UNITED STATES PATENT AND TRADEMARK OFFICE

APPLICATION NO.	FILING DATE	FIRST NAMED INVENTOR	ATTORNEY DOCKET NO.	CONFIRMATION NO.
10/661,287	09/12/2003	Feng Chen	TI-35766 (032350.B524)	7460
23494	7590	04/05/2005	EXAMINER	
TEXAS INSTRUMENTS INCORPORATED			WILLIAMS, HOWARD L	
P O BOX 655474, M/S 3999			ART UNIT	
DALLAS, TX 75265			PAPER NUMBER	
			2819

Office Action Summary	Application No.	Applicant(s)	
	10/661,287	CHEN, FENG	
	Examiner	Art Unit	
	Howard L. Williams	2819

Figure 3 : Second-order modulator filter

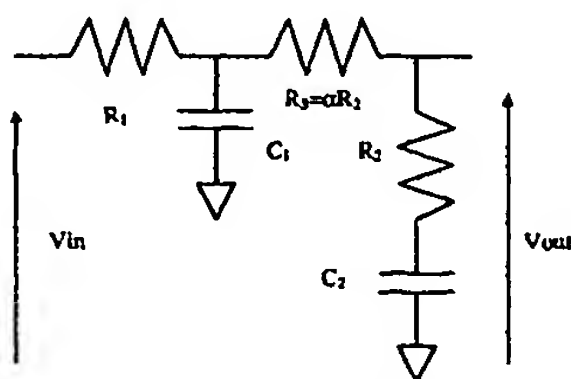
In reality Benabe's discloses a passive continuous time delta sigma converter that has passive continuous time forward path filter depicted in figure 3. Below is figure 3 of Benabe:

This filter has real negative zeros and poles. It can be easily realized using passive filters.

One possible realization is given by the following topology

The transfer function of Figure 3 filter can be expressed as

$$\frac{V_{out}}{V_{in}} = \frac{R_2 C_2 s + 1}{R_1 C_1 R_2 C_2 (1 + \alpha) s^2 + [R_1 C_1 + (R_1 + R_2 (1 + \alpha)) C_2] s + 1}$$

The Benabe article also includes the statement near the top of left hand column of the first page: "This approach will be applied in the case of filters using only resistors and capacitors elements." (Emphasis added). Accordingly, Benabe is seen to disclose a continuous time, passive filter using both resistors and capacitors. Benabe also provides a discrete time feedback loop noting the switch illustrated in the DAC of Fig. 1. The Chen article also uses discrete time feedback loop as seen below by the switches applying V_{ref-} and V_{ref+} . Benabe also references the Chen conference article or later journal article at the beginning of section III (Design Example) on page 470. This statement is seen as more than sufficient suggestion to combine under 35 USC 103.

The Chen article provides in figure 2:

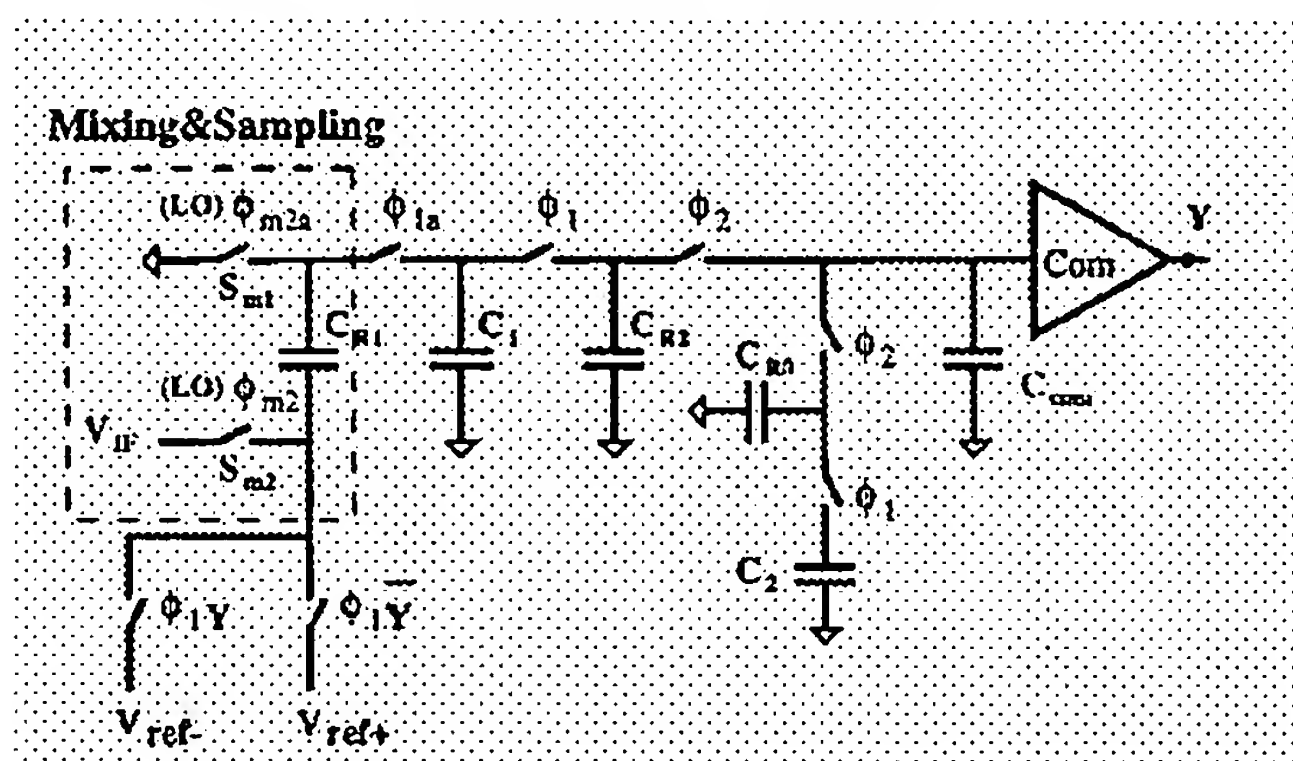
The element C_{R2} and the two switches clocked on Φ_1 and Φ_2 simulate a resistor as well known in switched capacitor technology. Capacitor C_{R0} and its two closest switches function likewise. The choice of subscripts for these two capacitors supports this reading. If one were to redraw the Chen article figure 2 circuit replacing the capacitors C_{R2} , C_{R0} and the adjacent switches one pretty much gets a single line figure 2 of the present application. Accordingly the rejection will be maintained.
